THE DEKALB COUNTY BOARD OF EDUCATION
CONSTRUCTION CONTRACT CHANGE ORDER
 Evergreen Construction

Project Name: Tucker Middle School- HVAC & Controls Replacement
Project No.: 23-752-026
Change Order No.: 001R2
Date: 10/01/2024

Project Description: HVAC & Controls Replacement
Reason for Change: Design Development, unforeseen conditions with existing facility, changes requested by DCSD

Scope of Work (for this change): Reconcile all PCOs 1 to 15 & 17 to 21 (16 skipped)

M-401

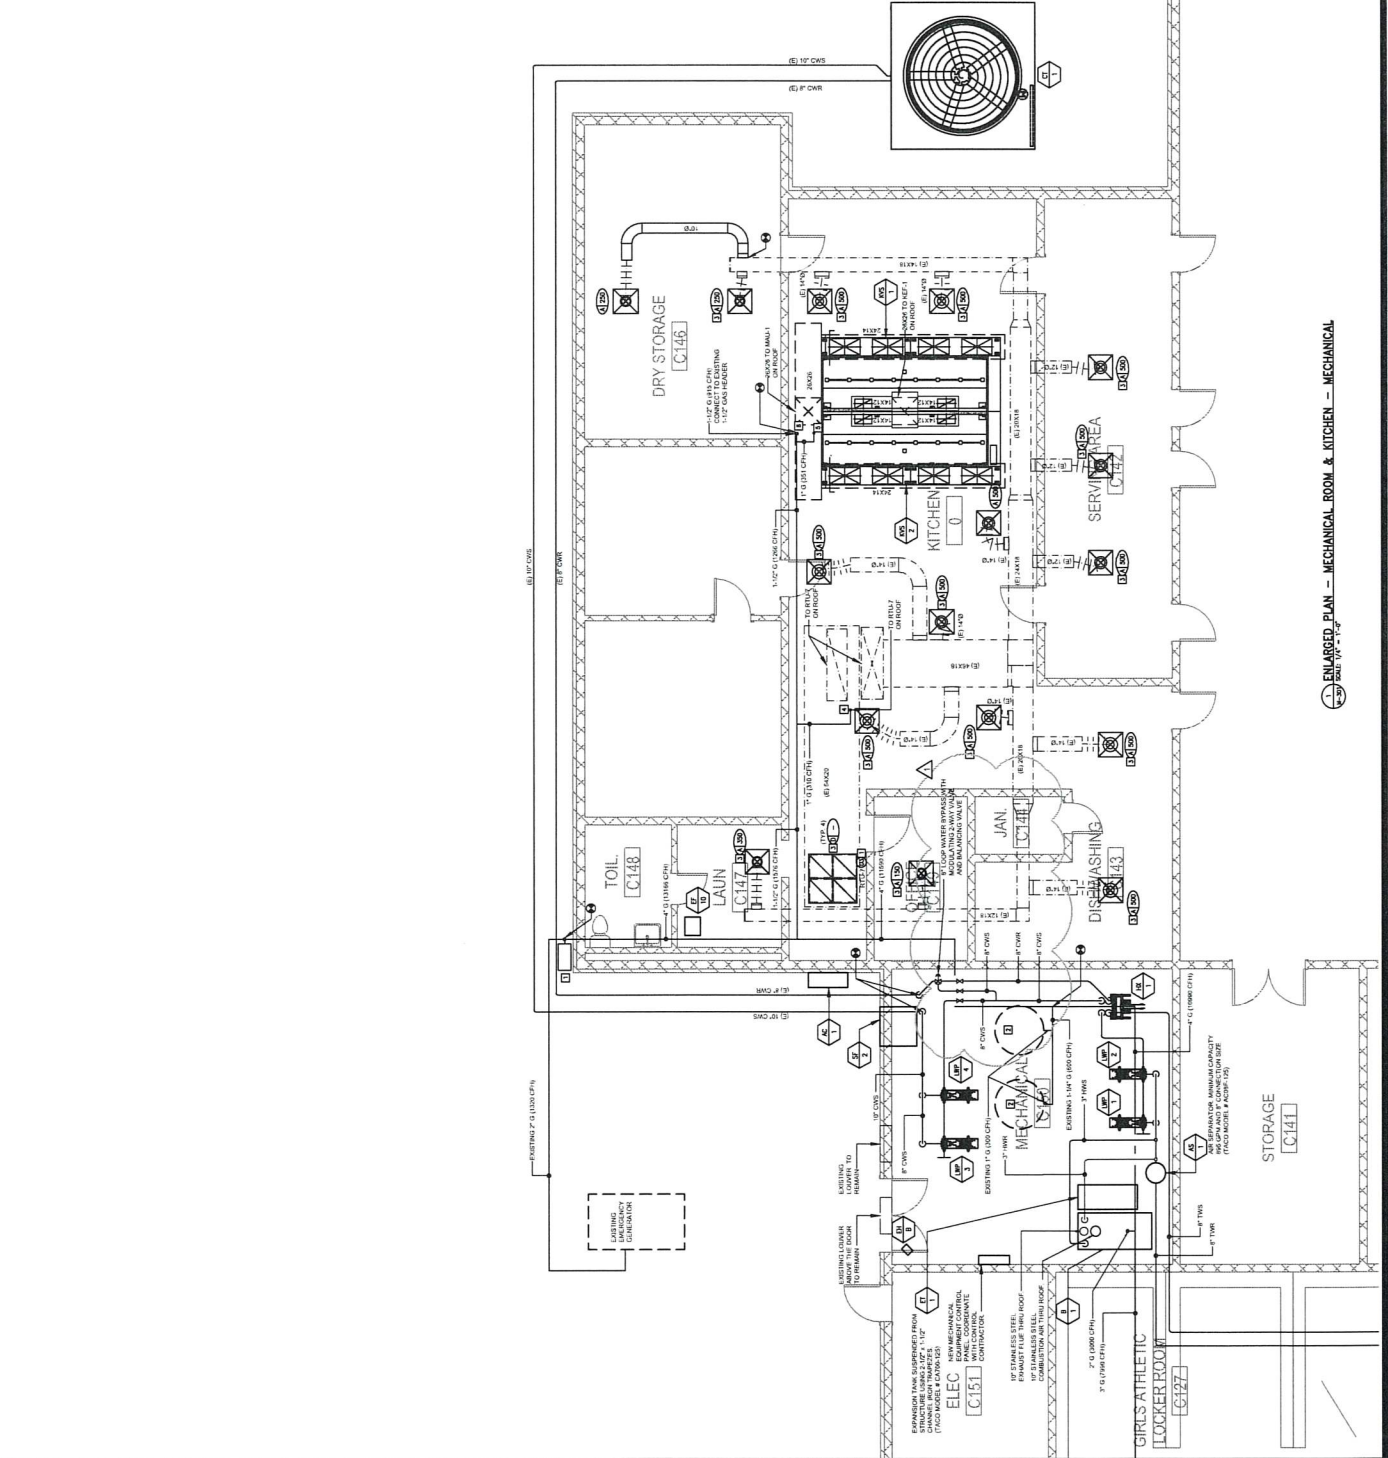
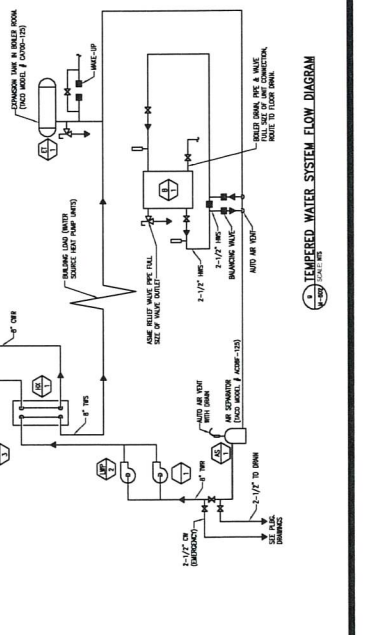
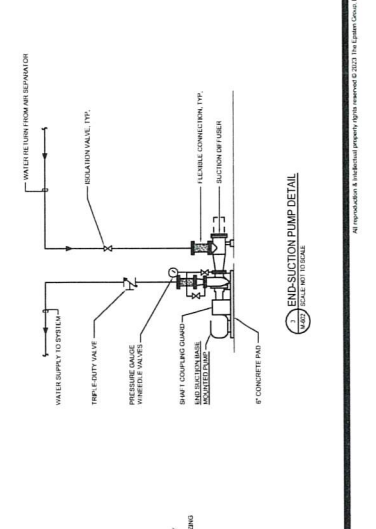
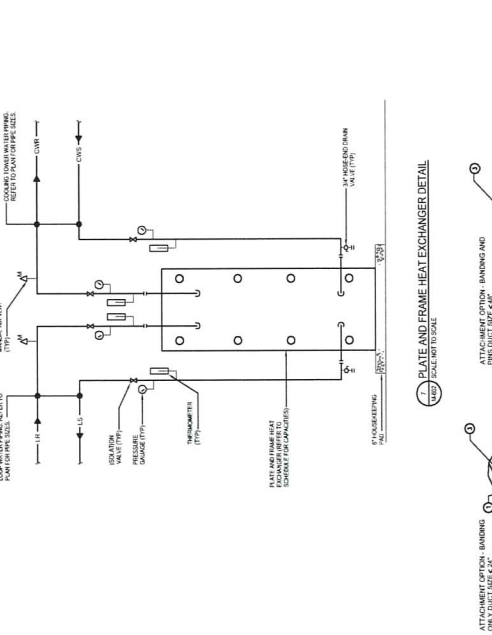
Detail: 5/M-602

Detail: 2/M-704

Two way valves are provided per the project specifications. However, there is no bypass valve on the loop. There is no way to maintain minimum flow if all isolation valves are closed. A bypass valve installed at a location along the loop would provide for redundancy in this scenario. Alternatively, in order to meet minimum flow, 3-way valves can be provided at unites selected by the engineer to provide for redundancy.

Detail: 2/M-602

Detail: 1/M-702

The details provided do not provide a location or size for an isolation valve for the cooling tower plant. Confirm if an isolation valve is needed, and provide sizing and location for this valve.

Provide appropriate design recommendation for either the single bypass valve, and provide valve sizing and location, or provide valve sizing and units for proposed 3-way valves.

Confirm if isolation valve is needed Provide sizing and location for cooling tower isolation valve.

See M-401 for revised cooling tower detail.

1. Furnish an additional eight (8) 2-way modulating WSHP loop bypass valves.
 - Valves to be installed by MC and connected to DDC system by CCI.
 - Six (6) 1 ¼" valves
 - One (1) 1 ½" valve
 - One (1) 2" valve
2. Furnish one (1) 8" 3-way bypass valve for Cooling Tower.
 - Valves to be installed by MC and connected to DDC system by CCI.
3. Furnish one (1) 10" 2-way Cooling Tower Isolation valve.
 - Valve to be installed by MC and connected to DDC system by CCI.
4. Engineering for additional valves is included within this change order.
